AGENDA
PLANNING AND ZONING COMMISSION MEETING
CITY OF CREVE COEUR, MISSOURI
MONDAY, OCTOBER 20, 2014
7:00 PM

Application #14-032: Approval of a Site Concept Plan for Barnes Jewish West County Hospital Campus and Approval of a Conditional Use Permit and Site Development Plan for a 16-Bed Hospice House at 970 North Mason Road

**APPLICATION TO PLANNING AND ZONING COMMISSION
#14-032 BARNES JEWISH WEST COUNTY HOSPITAL SITE CONCEPT PLAN
AND APPROVAL OF A CONDITIONAL USE PERMIT AND SITE DEVELOPMENT
PLAN FOR A 16-BED HOSPICE HOUSE**

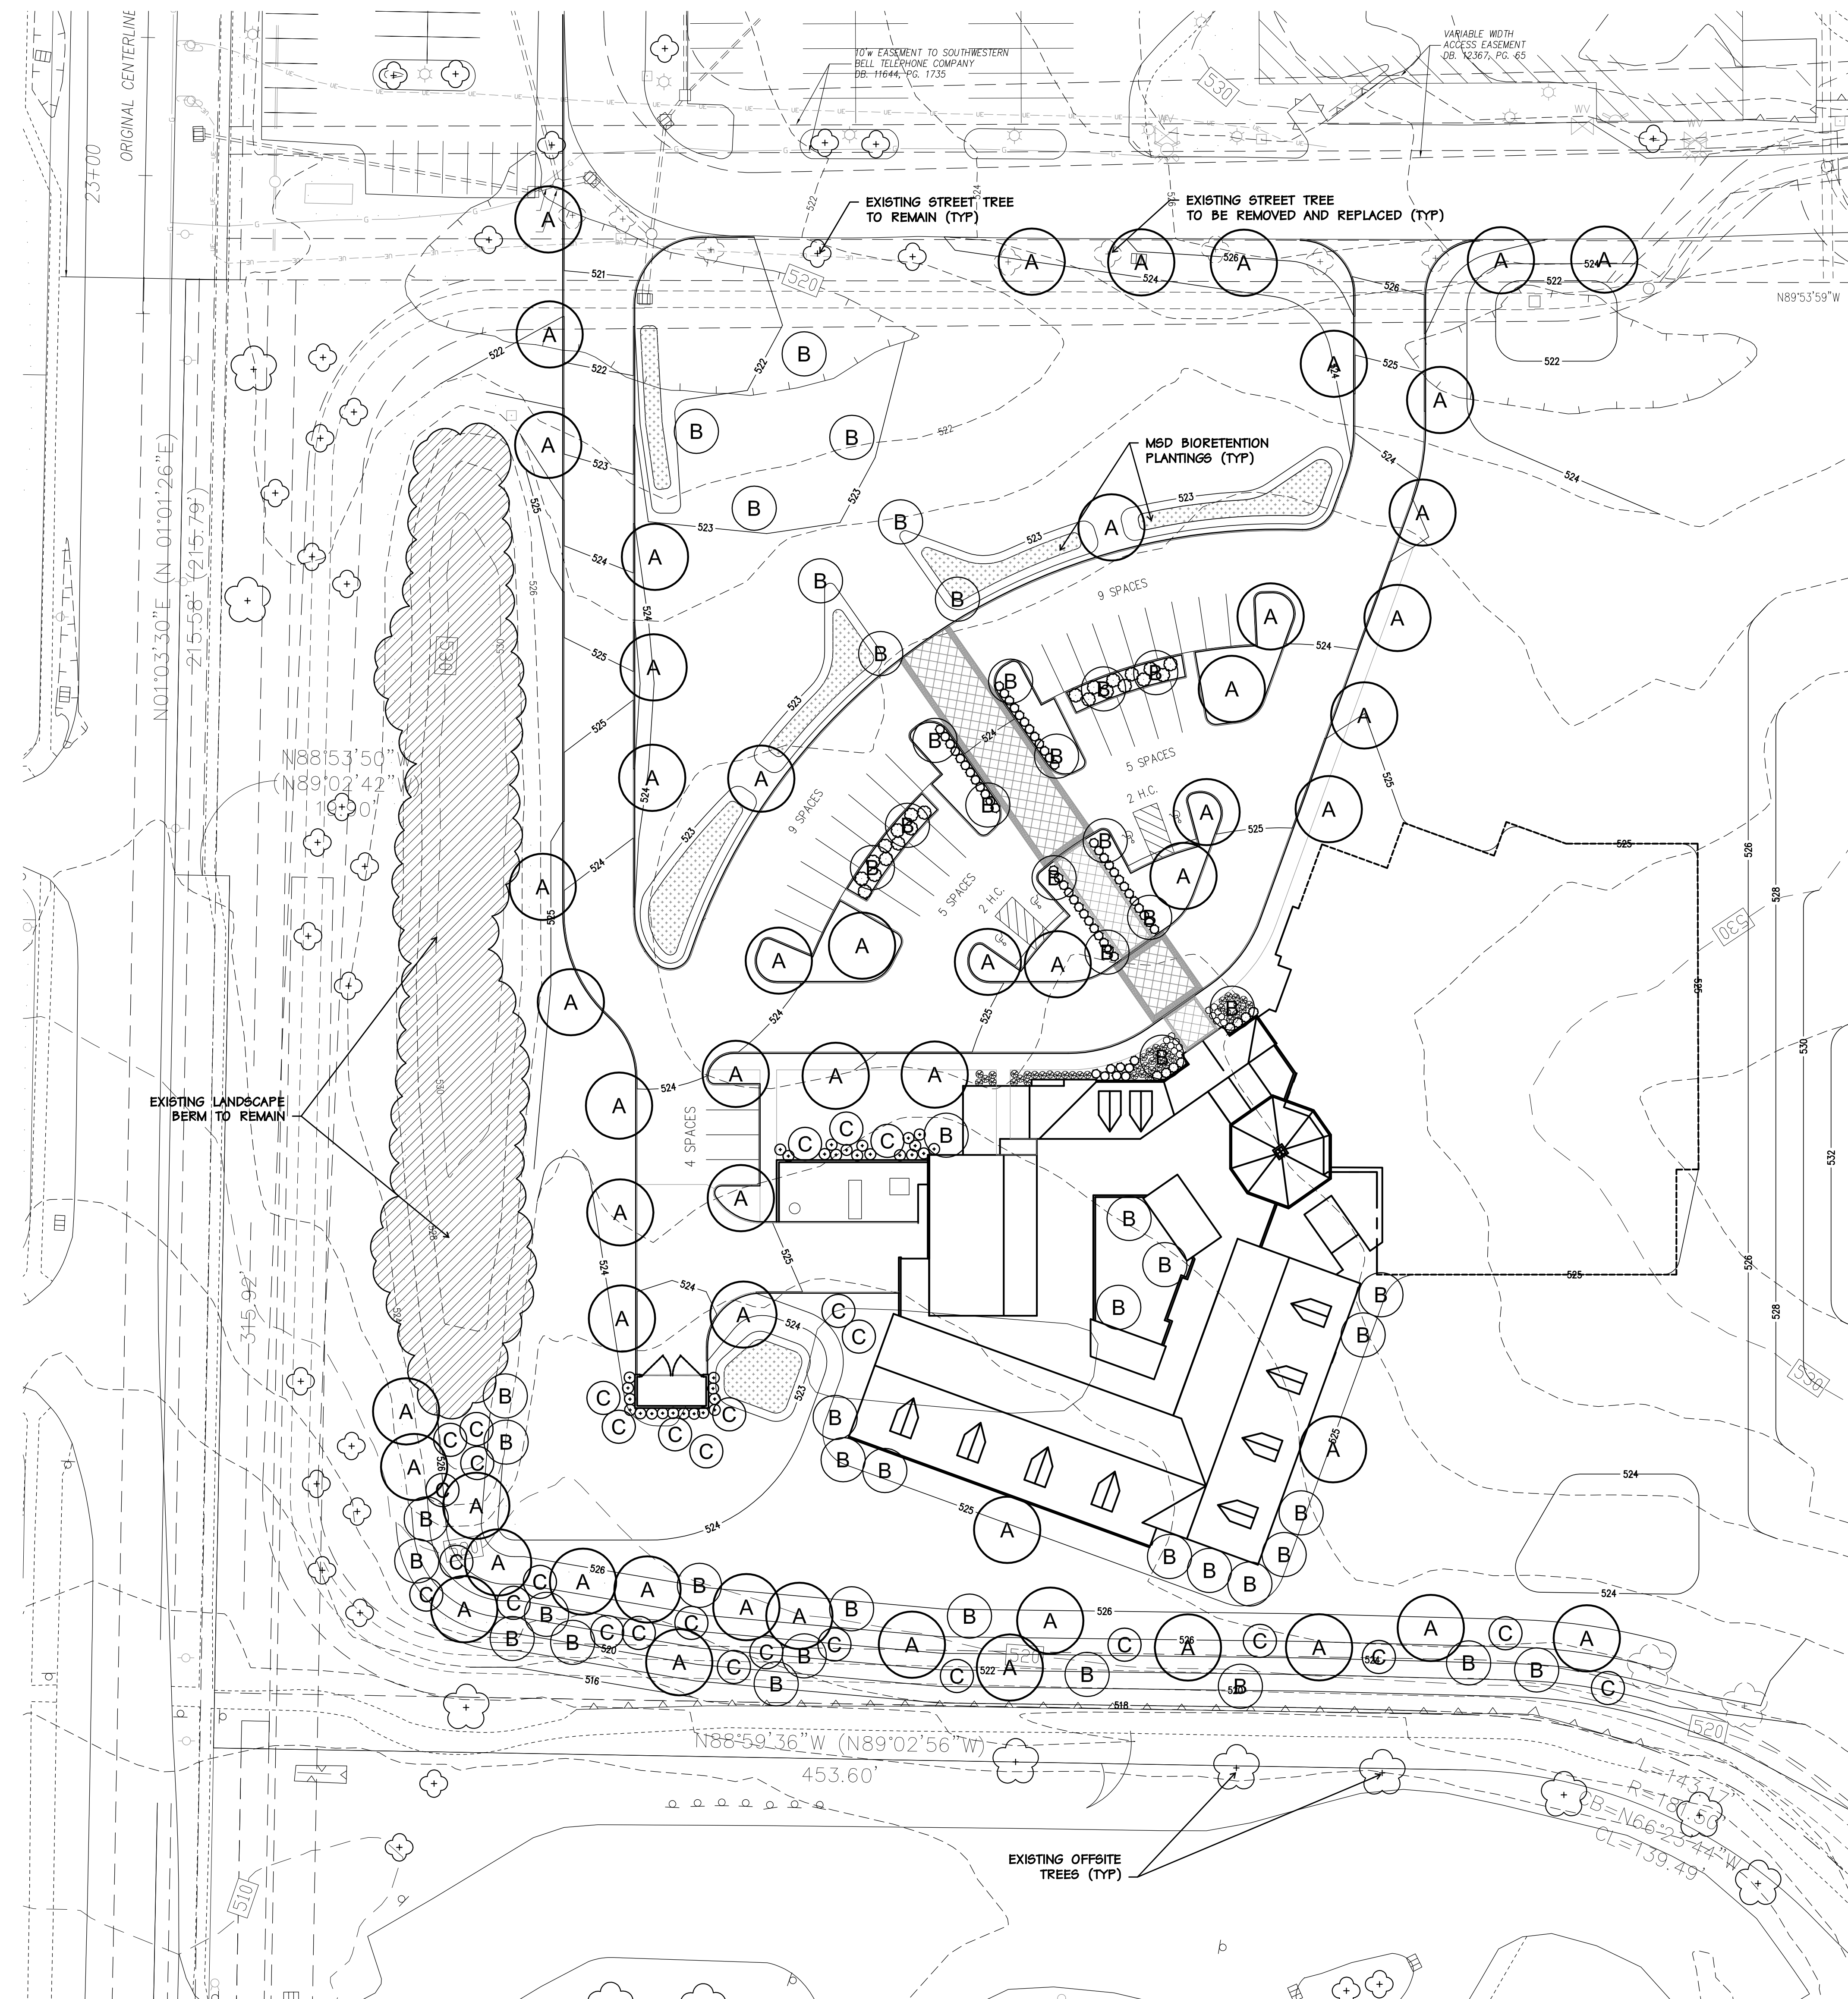
The submitted landscape plan shows that the Applicant will maintain the berm and existing trees along Mason Road and will continue these around the building along the south property line to provide screening from those visiting the school.

Street trees and landscaping are provided throughout the site to provide screening of the parking lot, the interior driveways and the circulation pattern, in conformance with the minimum requirements of the Zoning Ordinance. However, the plan does not provide much detail on the types of plant materials and the landscaping within the parking lot islands, only minimally meets with the Zoning Code requirements. Further, the planting design lacks visual detail and interest from the perspective of building occupants who might only be able to appreciate the landscape from inside the building. Therefore a condition of approval includes that the applicant shall submit a revised Landscape Plan that includes a detailed plant listing (not to include plant materials that are listed as invasive species, such as Burning Bush), and that will further the intent of the Design Guidelines around the building and within the parking lot.

As discussed above, the proposed Landscape Plan should provide significant screening of the building from the public right-of-way and for the property to the south. It meets with the minimum requirements for the minimum number of trees within the parking lot as well. However, as stated in the Design Guidelines discussion above, the landscaping near the building and within the island should be enhanced. Also, the plan does not indicate that an underground irrigation system has been included, contrary to the requirement below. Therefore, Staff has included a condition of approval that the Applicant submit a new Landscape Plan for the Zoning Administrators approval and that an underground irrigation system shall be included.

- The Landscape Plan for the hospice facility shall be revised to provide additional landscaping that more fully meets with the Comprehensive Plan and Design Guidelines as discussed in the staff report on Application #14-032, subject to the approval of the Zoning Administrator.

Figure 1: Detail of Site Plan submitted by Applicant

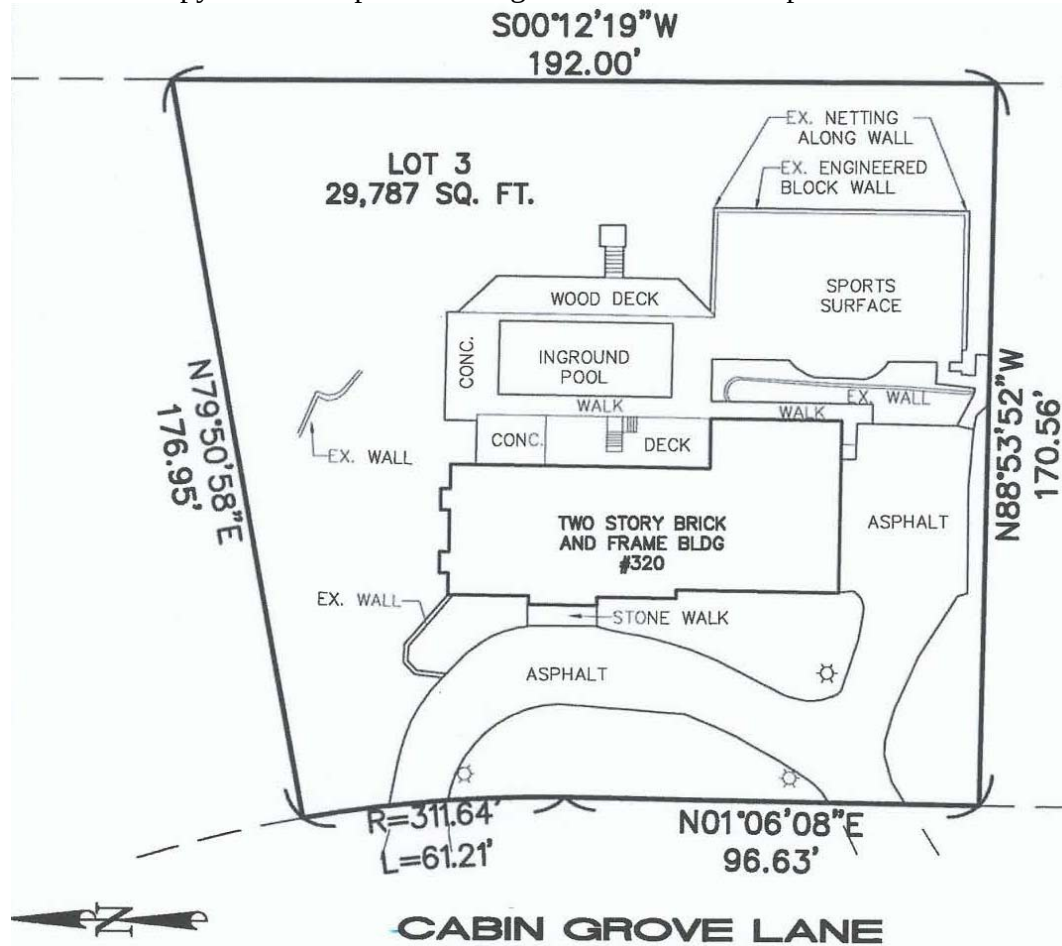
It should also be noted that, if the tall fence is moved back from the edge of the wall, a secondary barrier will have to be located to form a barrier keeping people from falling off the wall or gaining access to the top of the wall.
